Docket Nos. 50-327/328

SUBJECT: REVISED SAFETY EVALUATION ON THE TENNESSEE VALLEY AUTHORITY (TVA)
SEQUOYAH NUCLEAR PERFORMANCE PLAN

REVISED PRELIMINARY SAFETY EVALUATION REPORT
ON TENNESSEE VALLEY AUTHORITY:
SEQUOYAH NUCLEAR PERFORMANCE PLAN
PART 1: PROGRAMMATIC EVALUATION

Figure 1. MSIV Solenoid EQ Test Chamber Temperature

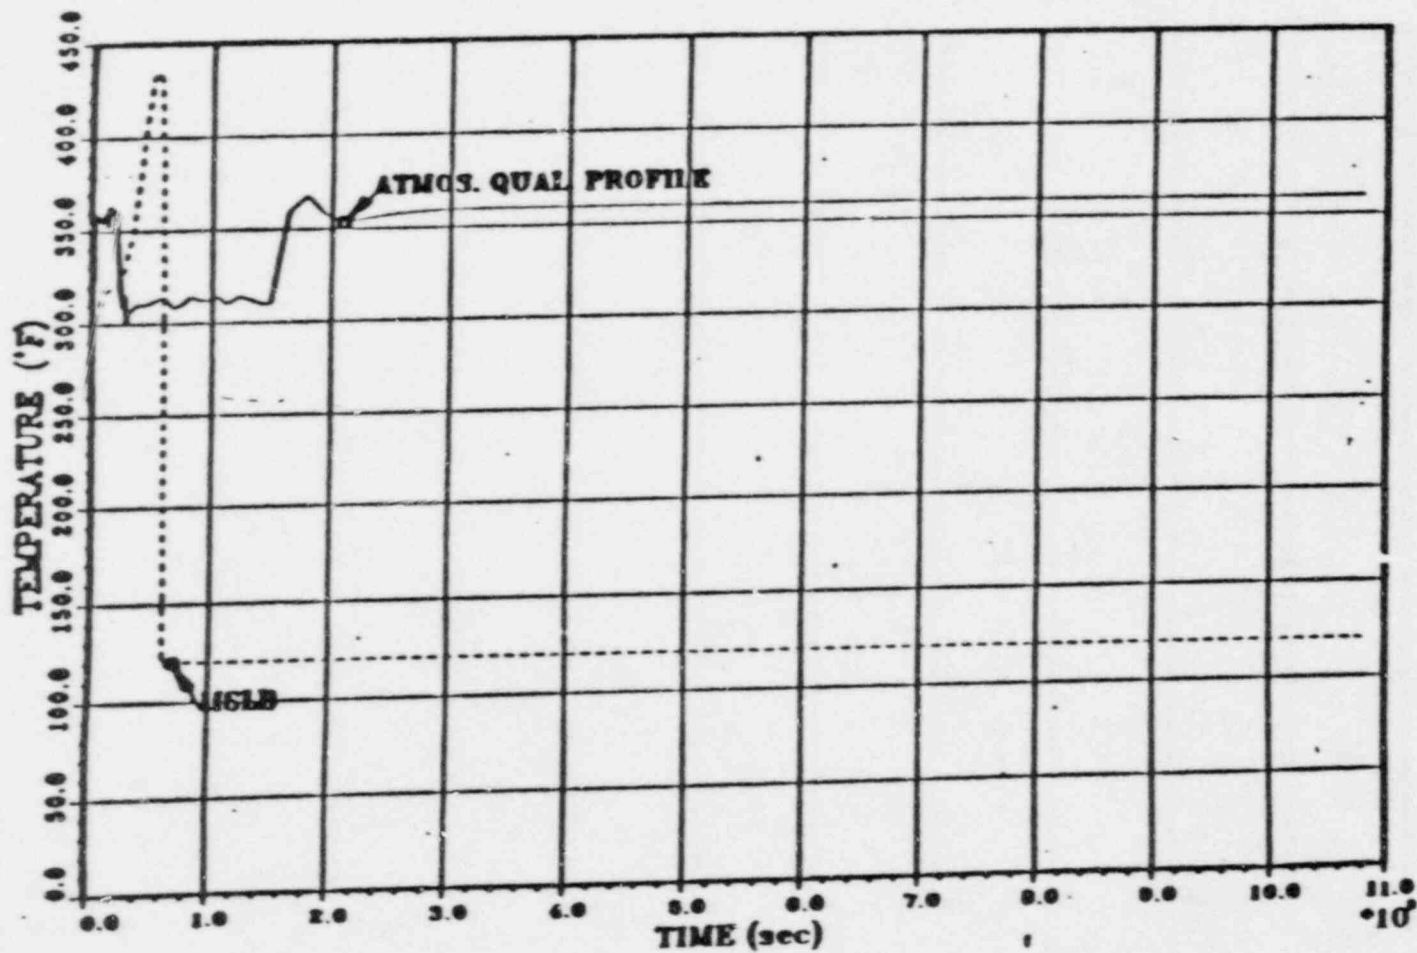
TVA also provided details of the guidelines used in constructing the heat transfer models. TVA's assumptions were made to conservatively increase the temperature predicted during a MSLB, while lowering the surface and internal temperatures resulting from analysis of EQ test chamber profiles. In this way, higher than expected surface and internal temperatures resulting from MSLBs are compared to lower than expected surface and internal temperatures derived from the qualification tests, thereby adding conservatism. The values of heat transfer coefficients used for the MSLB analyses were provided along with schematics of the models used. The Licensee concluded that qualification of the MSIV devices was established for each component by comparison of the calculated thermal response during a MSLB to the calculated response during qualification testing. The qualification for steam and moisture exposure is based wholly upon the existing qualification test results. The review of the existing qualification test results was not within the scope of this evaluation. The results of the existing qualification tests have been assumed to be acceptable during this evaluation. A sample of Licensee-supplied temperature profiles is included as Figures 1 through 3. Figure 1 represents the EQ temperature profile of a MSIV solenoid versus the MSLB temperature profile. Figure 2 is a plot of the calculated MSIV solenoid surface temperature during the MSLB. Figure 3 represents the calculated internal coil temperature during a MSLB as compared to the EQ test temperature.
